## SERVICE BULLETIN

### Super Raven Dash-M Series

#### TITLE: LINE ATTACHMENT STRUCTURAL ENHANCEMENT

Image 1: Affected canopies have a single 42 stitch bartack pattern in .75 inch T-III tape loop

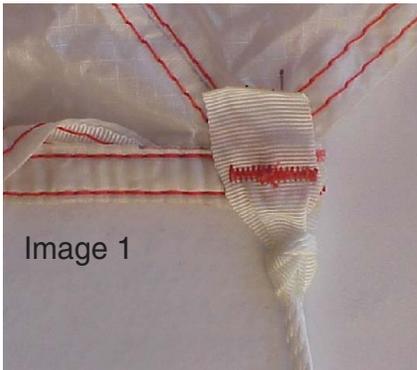
Affected canopies have serial numbers whose last 5 digits are below 35937 and can be further identified by the single 42 stitch bartack in the .75" T-III MIL-T-5038 tape line attachment loops (Image 1).

- 1) affected canopies use a single 42 stitch bartack in the .75" T-III MIL-T-5038 tape line attachment loops (Image 1).
- 2) damaged tape (image 2).
- 3) notice the 28 stitch tack on the loadbearing stitchrow beneath the line loop (Image 3)
- 4) add new bartack precisely on the loadbearing stitch row of the double needle seam" (Image 4)

Image 2: Damage at one of the 'B' line attachment points

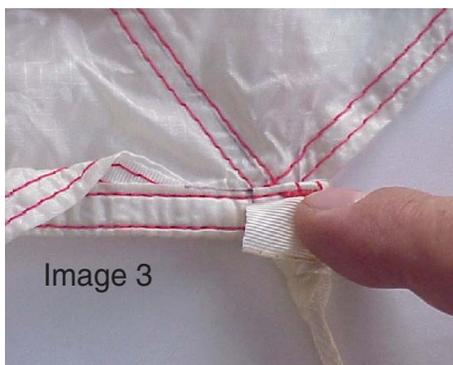
The failure mode was in the destruction of the .75 x T-III MIL T-5038 line attachment loop tape, manifested by pulling the attachment loop tape away from the canopy but leaving the associated stitching intact (image 2).

##### 9) Supplemental Data for Three Alternate Methods of Compliance

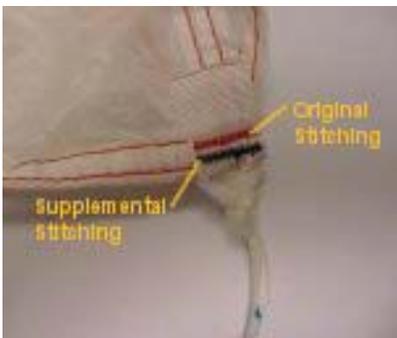
Since the original release of SB1221, we have approved three additional alternate methods of compliance for the structural enhancement for canopies affected by SB1221. All three methods are equally acceptable in terms of compliance with SB1221, provided the stitching meets the following criteria:

- supplemental stitching must be placed on or between the double needle stitch row AND
- supplemental stitching must capture the roots of the legs of the 3/8" T-III that extends diagonally up the rib.

The first alternate method of compliance allows rigger discession regarding the placement of supplemental stitching.

The second alternate method of compliance allows replacement of loops with new MIL-T-5038 Type III material.

The third alternate method of compliance allows the replacement of loops with new MIL-W-4088 Type1 material.
